ST/SG/AC.10/C.3/2009/37
4 September 2009

**MISCELLANEOUS PROPOSALS OF AMENDMENTS TO THE MODEL
REGULATIONS ON THE TRANSPORT OF DANGEROUS GOODS**

Safe stacking load on IBCs

Transmitted by the International Confederation of Plastics Packaging Manufacturers (ICPP)¹

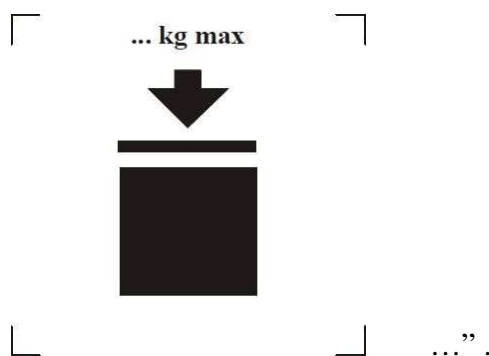
1. On the basis of proposal ST/SG/AC.10/C.3/2006/30 by the expert from the United Kingdom the Sub-Committee decided in July 2006 to introduce a new paragraph 6.5.2.2.2 to read: “6.5.2.2.2 The maximum permitted stacking load applicable when the IBC is in use shall be displayed on a symbol as follows:

2. The new stacking load symbol in 6.5.2.2.2. already causes misinterpretations despite the fact that the symbol is binding only from 1 January 2011. The existing practice of multiple stacking of IBC's in warehouses has been put in question by IBC users and control bodies.

Bearing in mind that the Model Regulations are intended only for transport and not for storage, the phrase "when the IBC is in use" in 6.5.2.2.2 is a source of misunderstandings for users of IBCs outside the transport chain.

3. To avoid these misunderstandings in future, ICPP proposes to amend the first sentence in 6.5.2.2.2 and the symbol.

4. Amend 6.5.2.2.2 to read as follows:

"6.5.2.2.2 The maximum permitted stacking load applicable for the IBC during transport shall be displayed on a symbol as follows:
